City Manager's Office
City Hall
300 LaPorte Ave.
PO Box 580
Fort Collins, CO 80522
970.221.6505
970.224.6107 - fax
fcgov.com

September 2, 2015

RE: City of Fort Collins' Comments to the Supplemental Draft Environmental Impact Statement for the Northern Integrated Supply Project

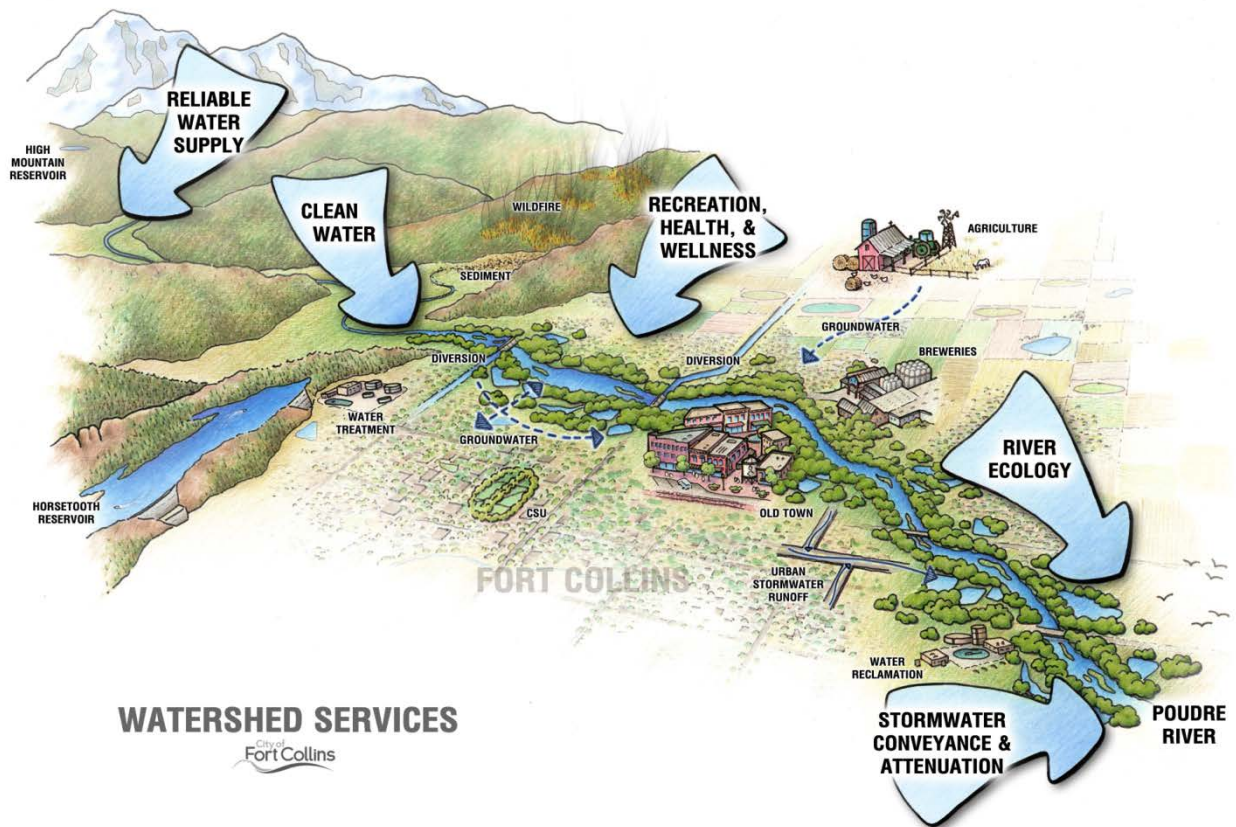
Comment: Fort Collins has conducted various studies on the Poudre River designed to increase the understanding of current and potential future conditions. As the owner of water, wastewater, and stormwater utilities, Fort Collins is constantly conducting studies related to the functions of these enterprises. As a landowner, municipality, and steward of the land and water for current and future residents, Fort Collins has also sought to better understand the Poudre River beyond the scope of these vital utilities through conducting studies on other aspects of the river. Several of those studies are identified in and provided with these comments. In particular, studies have been designed to further understand site specific issues (such as land use in the floodplain), drivers (such as inundation of the riparian zone) and thresholds (such as sediment mobility flow thresholds) that influence the condition of ecological components and also to understand the system as an integrated sum of its parts.

The SDEIS inaccurately describes the Poudre River as having an ecosystem that has already passed a biological threshold and that is on a boundlessly declining trajectory. The SDEIS concludes that important ecological processes such as sediment mobility and support of riparian functions are not currently occurring and therefore additional reductions are “*predicted to reinforce or accelerate the well-established trajectory*” (SDEIS Section 4.9.9 Table 4-69) (emphasis added). Based on this proposition, the SDEIS concludes that any negative impacts from the proposed actions of NISP are minor or imperceptible, and not significant when considered against this supposed inevitable trajectory towards an impoverished system. However, neither NEPA nor the CWA allow agencies to disregard the impacts of proposed actions by assuming that environmental resources will be lost regardless.

Figure 3-101. Percent change in adult brown trout habitat from existing conditions on the Colorado River below Windy Gap for an average water year.

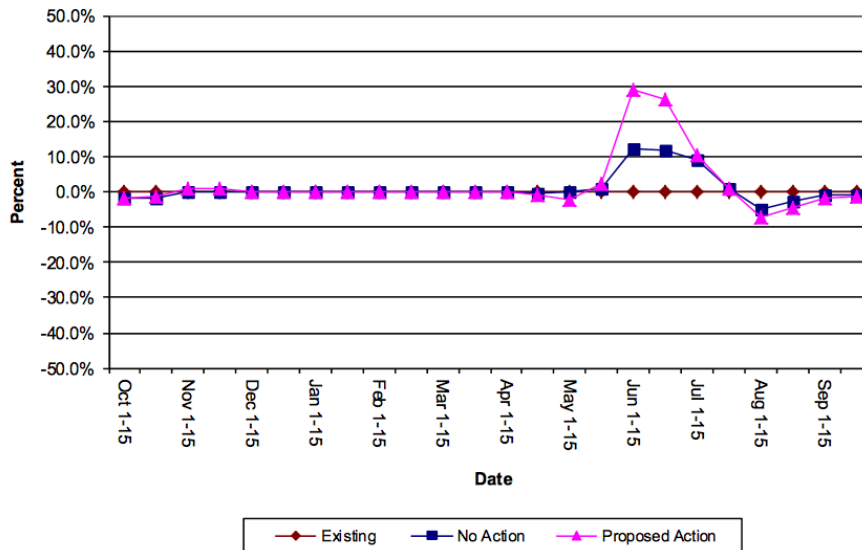
Page 4-314 of the SDEIS discusses changes in habitat with changes in flow. However, there is no means to verify any of the statements since computational data for habitat-flow time series is not presented in the supporting aquatic resource technical documents. For example, the recent EIS for the Windy Gap firming project included the basic habitat time series data by water year type as part of the technical supporting documentation (see following example Figure 3-101, Windy Gap FIRMING Project FEIS). The display of habitat by water year type or actual year allow the reader to make a direct comparison of habitat change between alternatives.

The aquatic habitat analysis up through the development of habitat versus flow determinations follows the standard approach used in instream flow studies. (Bovee et al. 1998, USGS 2001). The divergence from the standard approach is in the calculation of habitat over time. The use of a synthesized habitat values based on recurrence and then a single average value derived from the synthesized data masks the relationship of habitat over time. This approach does not allow a full analysis of impacts to the aquatic resources within Fort Collins, especially in the downtown corridor, which is highly valued.

The analyses and conclusions must be revised in these proceedings to address the deficiencies described above

SDEIS Section 4.5.1 Methods, Pages 4-176 to 4-177

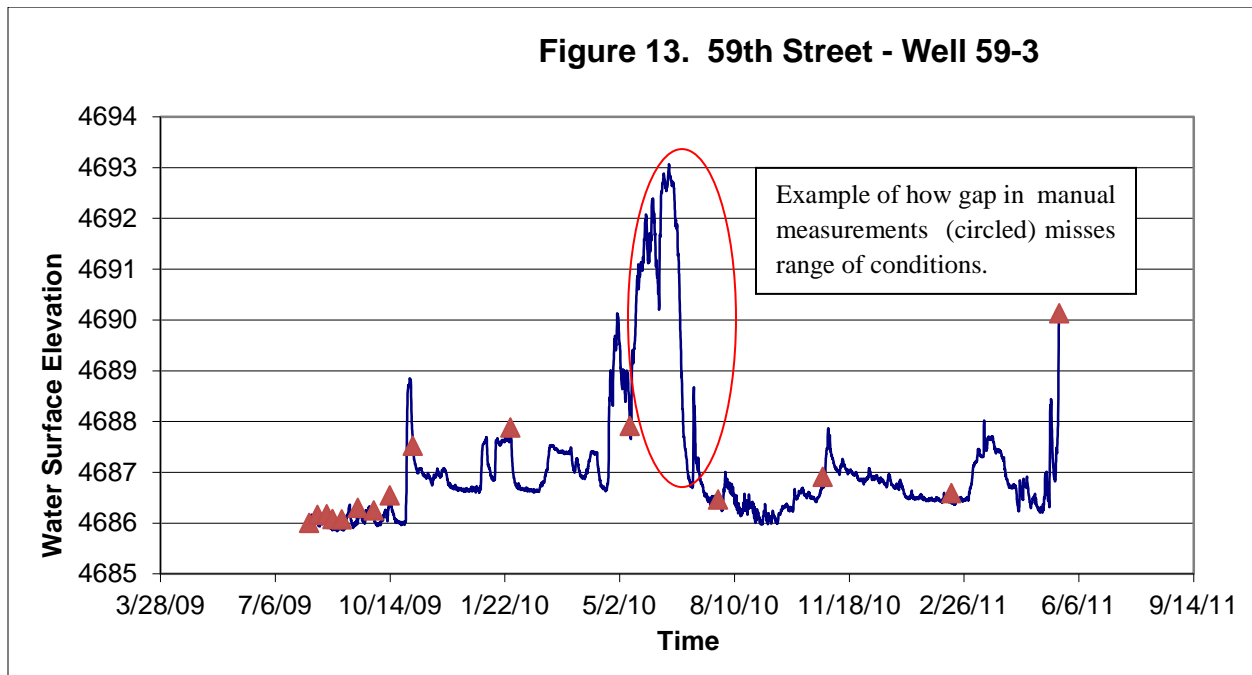
Comment: Data used to establish the river stage-ground water relationships appear not to be representative, complete, or consistently interpreted as described below.

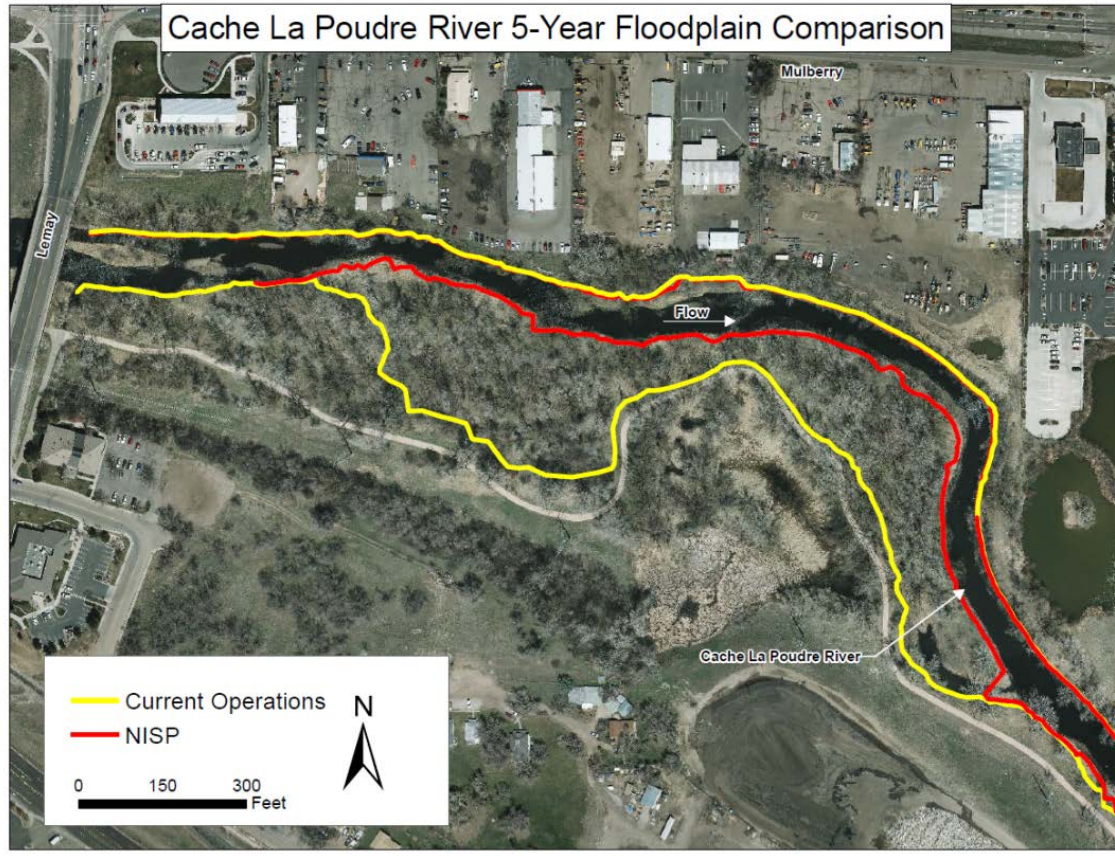
Fort Collins and its consultants calculated the 5 year flow at the USGS gage at the Lincoln St. gage using methods described in USGS bulletin 17b for historic, current conditions and Alternative 2 flow scenarios (see ERM Supplemental Report, Current Conditions and Alternative 2 and USGS, 1982). Respectively this flow is 3,486, 3,018, and 2,366 cfs. According to these flow values, this “moderate flow” appears within range of flows most affected by the preferred alternative.

The first three columns in this table present the average width (in meters including both sides of the river) of the 5-year floodplain for three RHAF river segments under various 5 year flow scenarios. The percent change from Current Conditions to the Preferred Alternative can be calculated as a way to present the expected change in ecologic services. This methodology and these river segments, are explained the RHAF (City of Fort Collins, 2015a). Due to bank armoring and channel constrictions the riparian forest is narrow for significant lengths in each of these river segments. In contrast, the sections with more natural low-lying floodplain topography are more likely to receive the benefits of inundation. For example, as portrayed in the photo below, the river section downstream of Lemay Ave. currently inundates the forest under the 5 year flow. With NISP the 5 year flow will not extend into the forest at all.

The analysis should be revised to provide a spatial assessment of inundation alterations and the effects to the riparian environment, as described above.
